SERVICE PROCEDURE

16502
APRIL 2016

SUBJECT: SAFETY RECALL
Hood Latch Straps on certain CE S models built 02
March 2015 thru 13 January 2016

Figure 1. Hood Latch Strap Retainer Housing

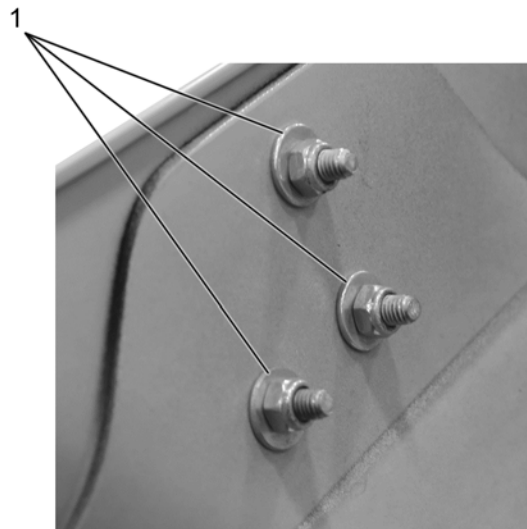
5. Raise hood to allow access to three nut and washer assemblies (Figure 2, Item 1) securing hood latch strap retainer housing (Figure 1, Item 2).

6. Remove three bolts (Figure 1, Item 1), along with nut and washer assemblies securing retainer housing. Pull out retainer housing and disengage hood strap at retainer housing.

9. Using kit-supplied strap and speed nut, align and position latch handle onto strap. Insert previously removed pin through latch handle and strap. Install kit-supplied speed nut onto pin.
10. Position opposite end of kit-supplied strap into retainer housing.
11. Position hood latch strap retainer into place; install previously removed bolts, nut and washer assemblies. Using torque wrench, tighten to 27 - 44 lb-in (3 - 5 N·m).
